DA Access Report

21335

31 Stanley Crescent & 2A Bringelly Road, Kingswood NSW

This Access Compliance Report is to accompany a Development Application for the development proposed at 31 Stanley Crescent & 2A Bringelly Road, Kingswood NSW

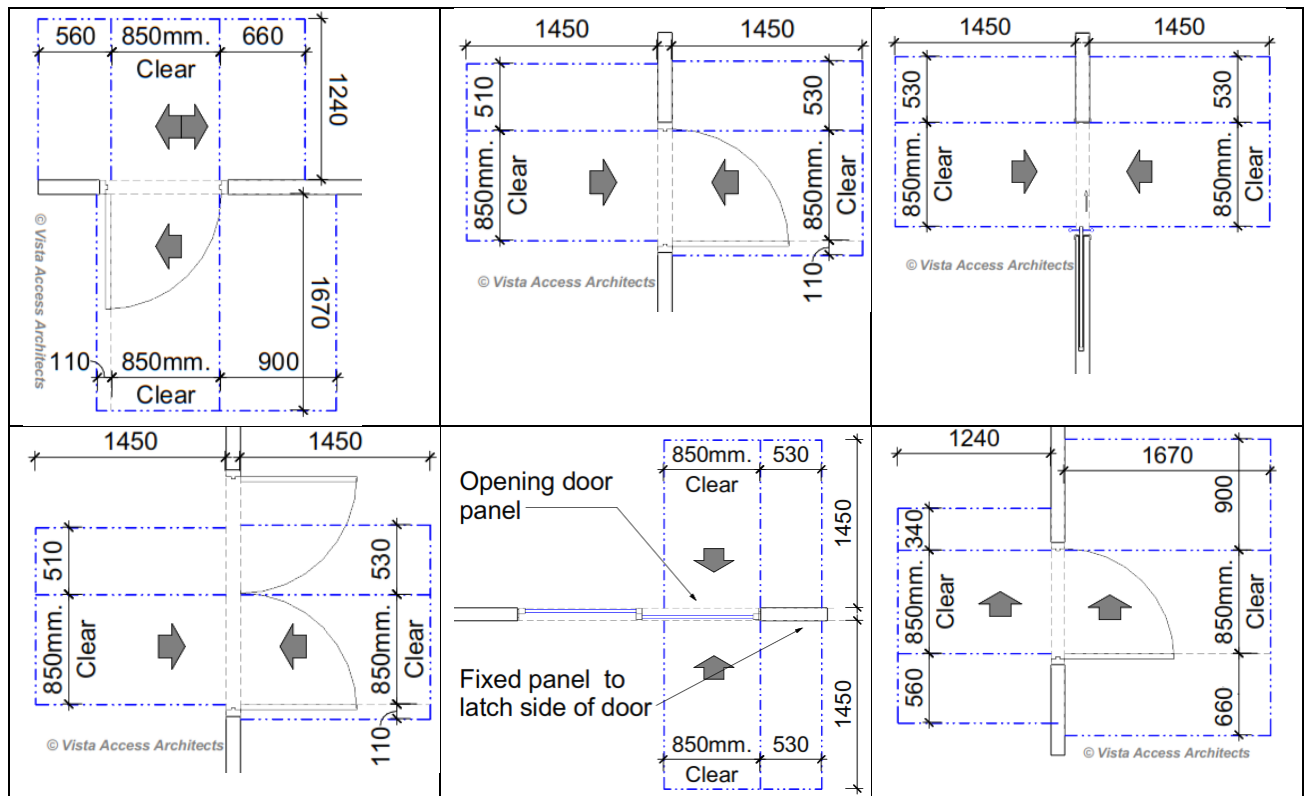
Complies.

Access has been provided to and within all areas required to be accessible.

2 Low rise platform lifts are used which are required to be BCA compliant.
